HISTORIC AND DESIGN REVIEW COMMISSION

August 17, 2022

HDRC CASE NO: 2022-291
ADDRESS: 801 N MAIN AVE
LEGAL DESCRIPTION: NCB 787 BLK 7 LOT 15- 16 & S TRI 53.79 FT OF 10
ZONING: D
CITY COUNCIL DIST.: 1
APPLICANT: Robert Flores/American GI Forum-National Veterans Outreach Program, Inc.
OWNER: American GI Forum-National Veterans Outreach Program, Inc.
TYPE OF WORK: Construction of a 4-story residential structure
APPLICATION RECEIVED: August 01, 2022
60-DAY REVIEW: Not applicable due to City Council Emergency Orders
CASE MANAGER: Edward Hall

The applicant is requesting a Certificate of Appropriateness for approval to construct a 4-story, residential structure at 801 N Main, located within the Downtown Design District.

SHEET TITLE.
EXTERIOR
ELEVATIONS

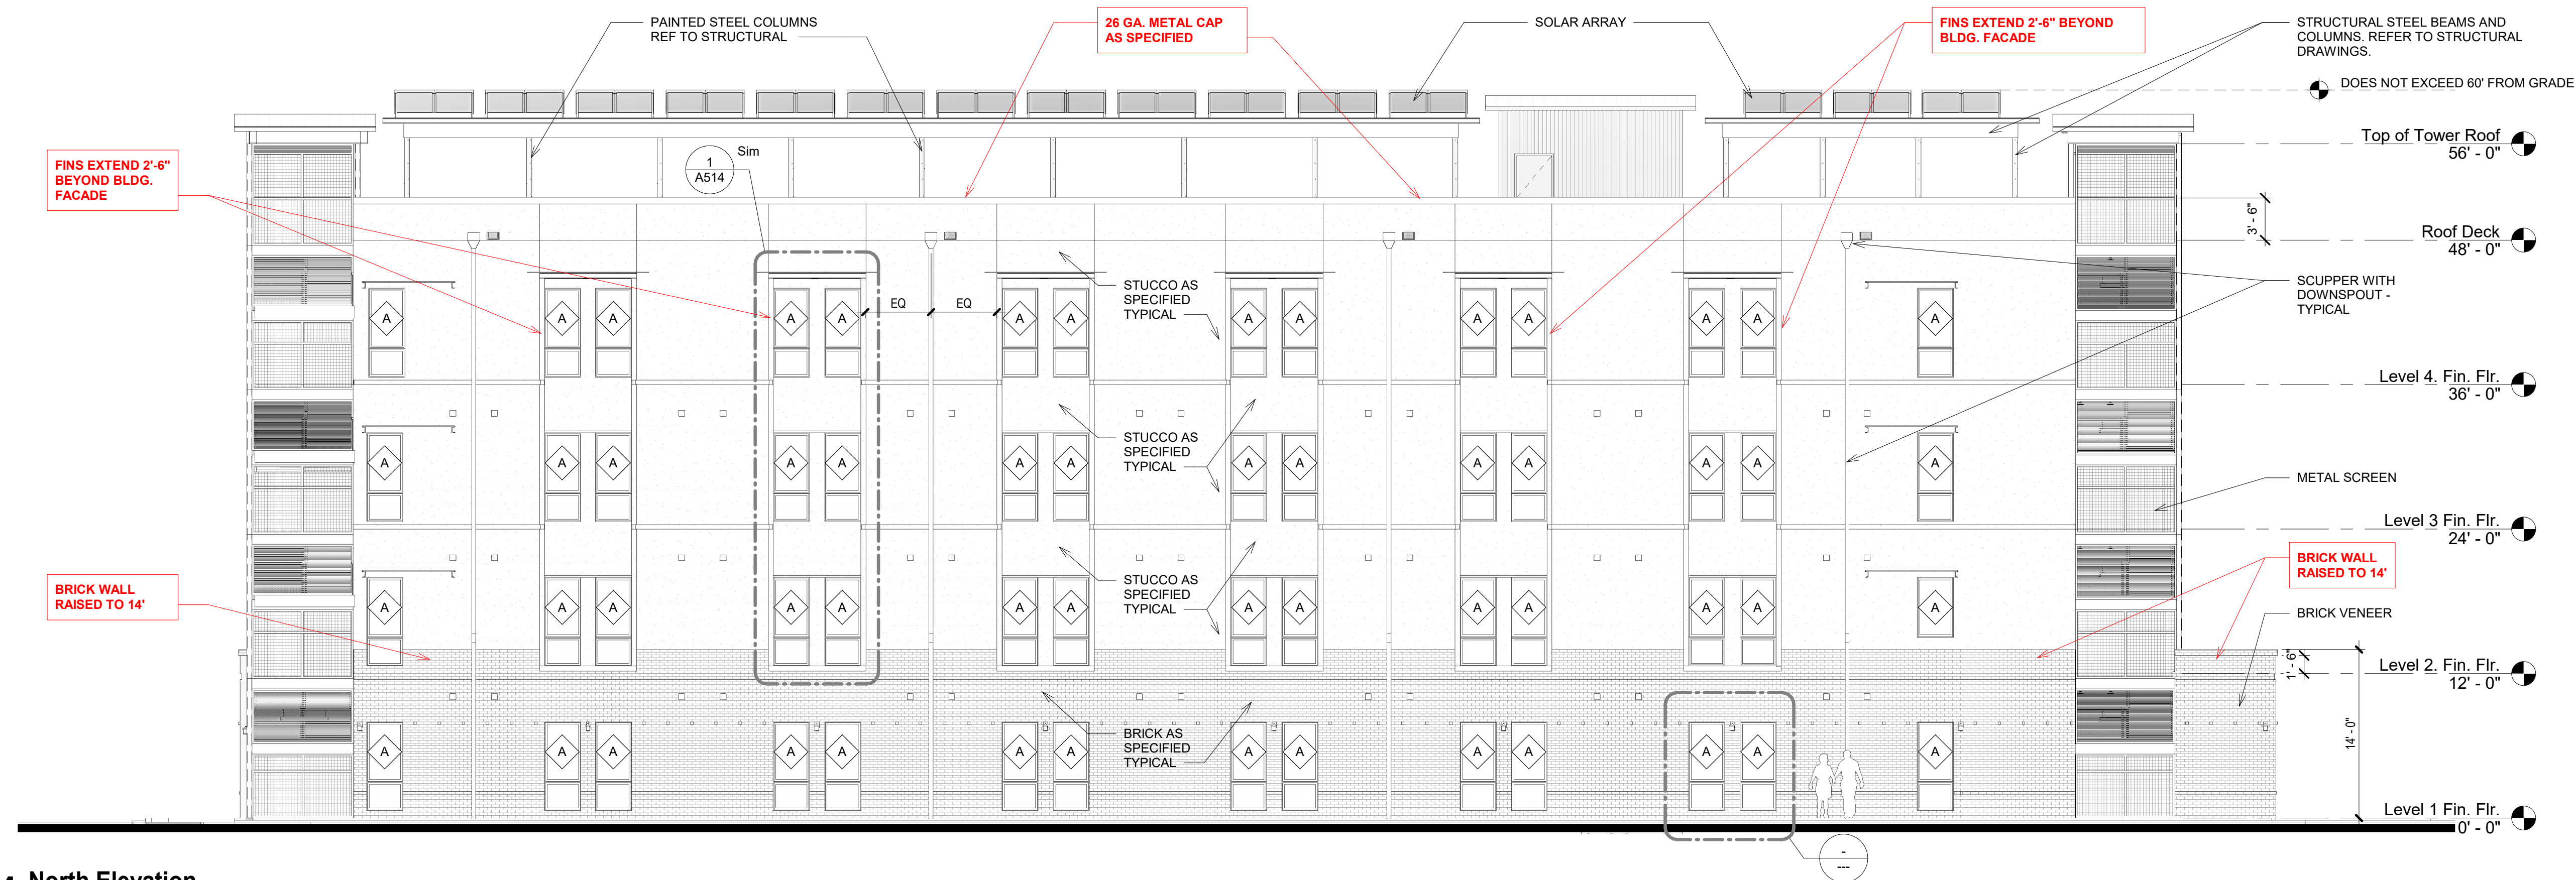
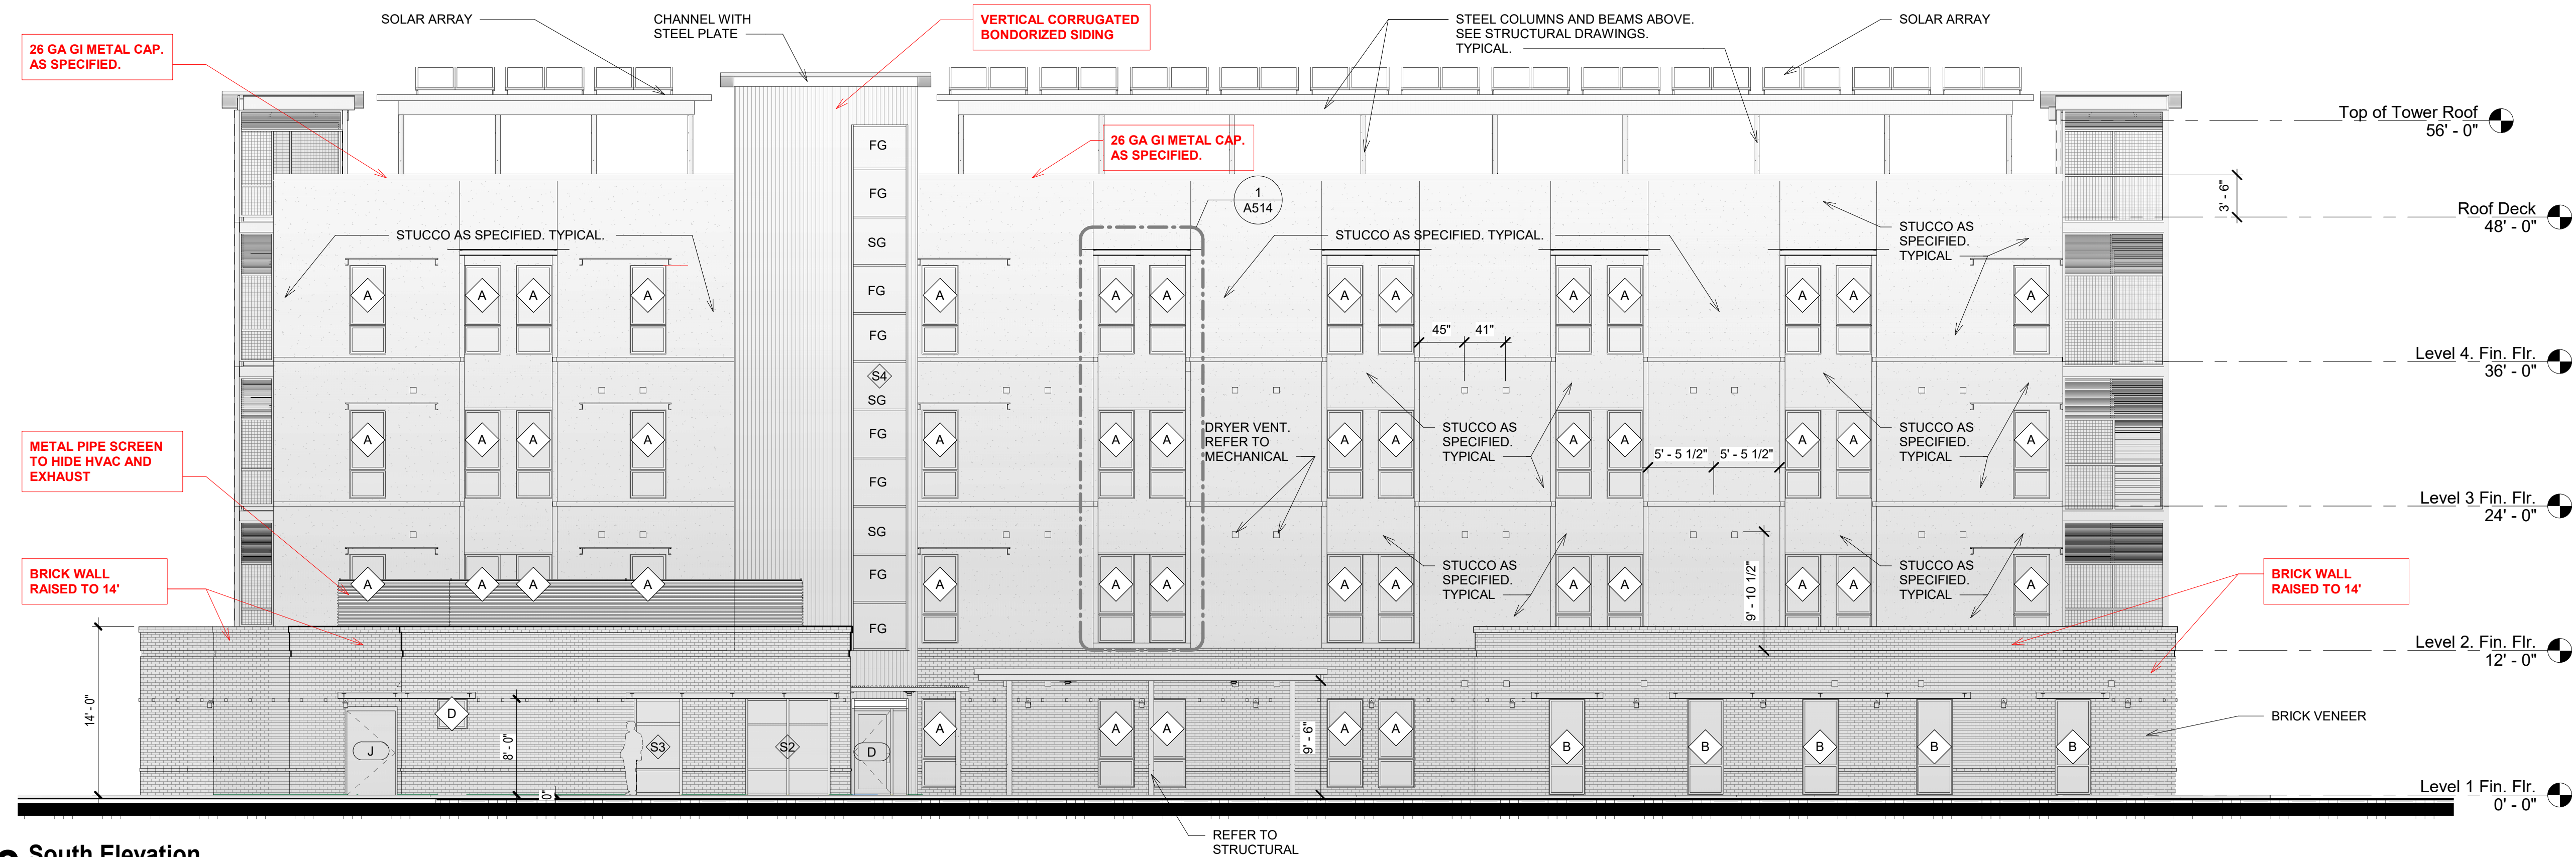
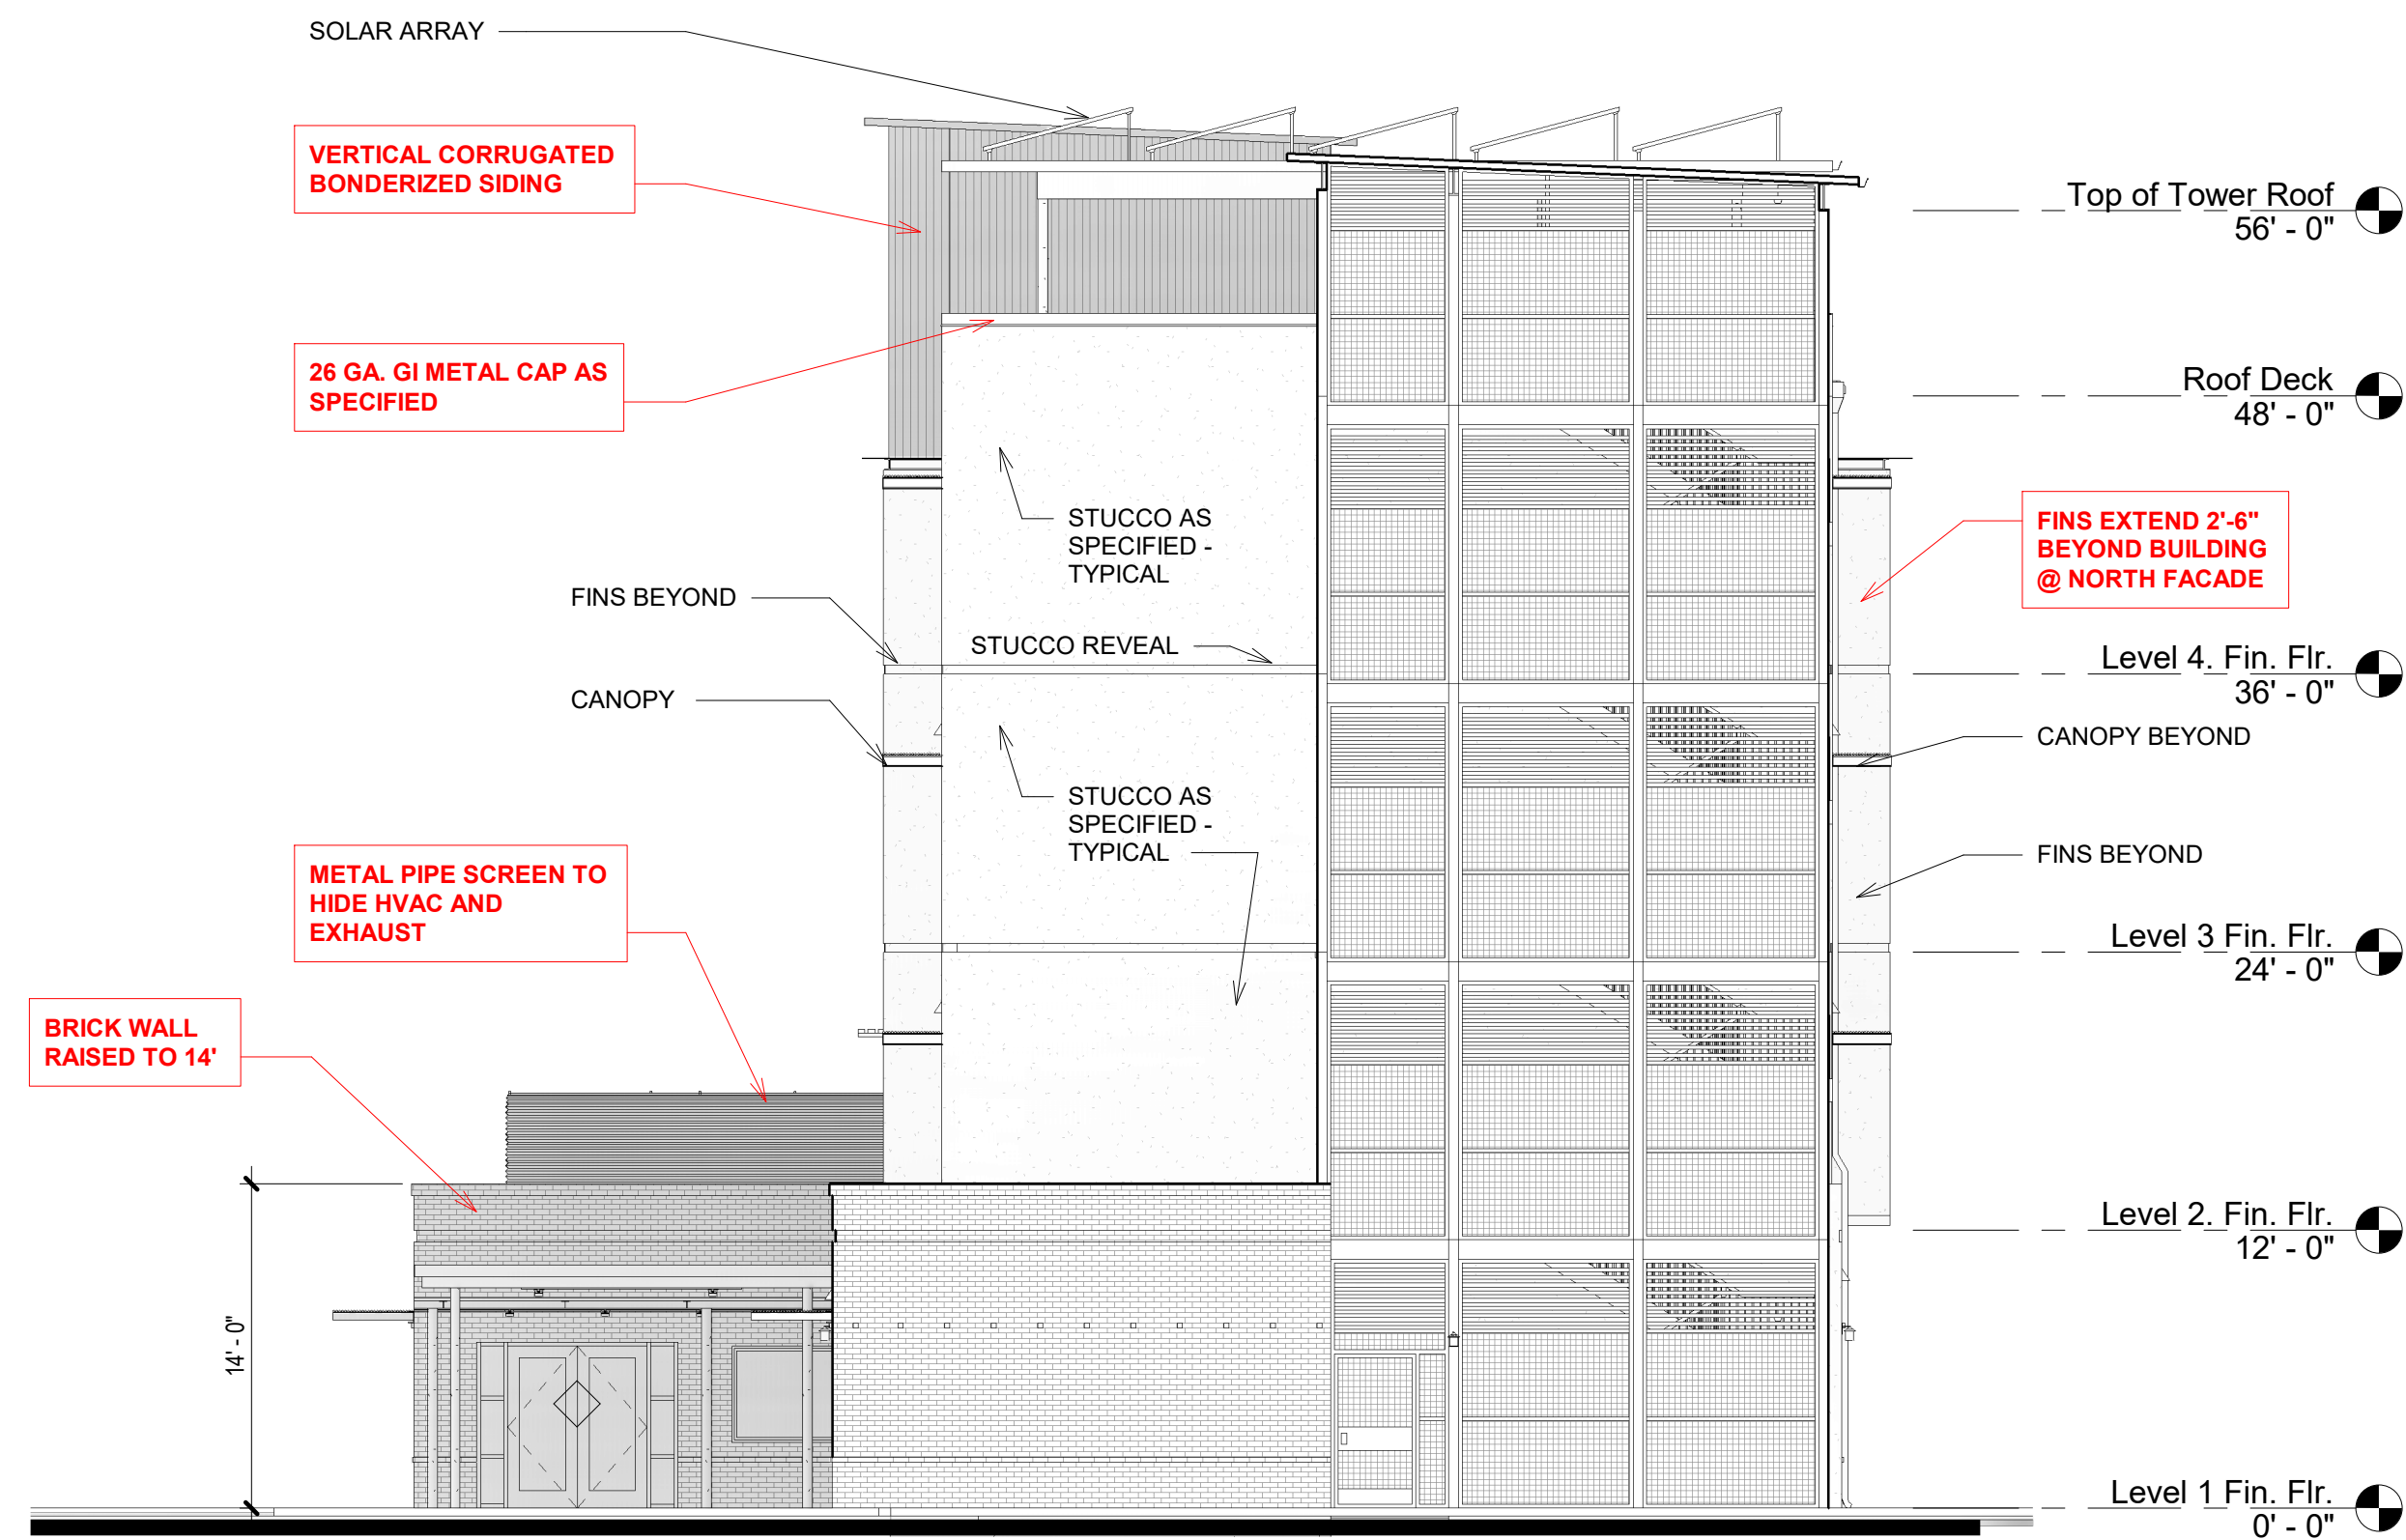
- iii. That the applicant introduce architectural elements to the north façade to break up the façade and that the applicant introduce architectural elements, such as a cornice to create a building cap, as noted in finding i. A change in materials or material profile and color should be explored to meet these requirements. *This stipulation has been met.*

- j. MASSING & STREET WALL – The applicant has proposed for the structure to feature four (4) stories in height. The Downtown Design Guide 5.A.i. notes that large building facades should be divided so that no building section is longer than 100 feet in length. Additionally, structures should feature a base, middle and cap,

should maintain the alignment of other horizontal elements on the block and should feature floor to floor heights similar to other structures on the block. Staff finds the overall massing of the proposed new construction to be appropriate as the applicant has proposed façade separating elements, a distinctive building base and cap and variations in material colors and textures.

- k. MATERIALS – The applicant has proposed materials that include brick, stucco, corrugated metal siding, metal screening, and aluminum windows. Generally, staff finds the proposed windows to be appropriate and consistent with the Downtown Design Guide.

- l. WINDOWS – The applicant has proposed anodized aluminum windows. The Downtown Design Guide notes that windows should add depth to a building's façade and should be well detailed where they meet façade materials to provide adequate weather protection and to create a shadow line. Staff finds that that windows should feature dark colored frames, no faux divided lites or faux internal grilles. For windows that are not surrounded by wall fins, staff finds that windows should be recessed at least two (2) inches within walls.
